Development Services Staff Report

File Number PL2022-168

File Name SIGN APPLICATION – Legacy Park

Planning Commission Date May 12, 2022

Figure 4 - Typical specification of proposed ground signs

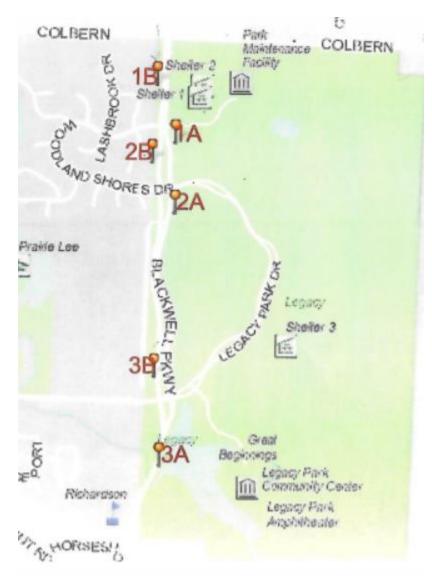
Legacy Park is a 692-acre site with various facilities that include a community center, early education center, operations building, amphitheater, sports venues and trail. Each of the three park entrances along NE Blackwell Pkwy have existing freestanding signs. The proposed ground signs will provide wayfinding for all of the park facilities at each of the park's three entrances. The signs have a Craftsman

or Prairie Style design influence and are composed of stone bases, aluminum posts and aluminum panels. The sign design and materials are compatible with existing park architecture for buildings and existing entrance and internal park signage.

Given the expansive 692-acre site, the number of facilities housed within the park, and need for improved wayfinding along NE Blackwell Pkwy, staff believes the proposed signs maintain a compatibility and proportionality that is appropriate for the site. With the conditions of approval below, the application meets the requirements of the UDO and Design and Construction Manual (DCM).

- 1. A total of three (3) freestanding signs (existing + new) shall be allowed at each of the three park entrances along NE Blackwell Pkwy as shown on the sign location map. The new ground signs shall not exceed the following size standards: 8' height; 57 sq. ft. sign face area; and 104 sq. ft. sign structure area.
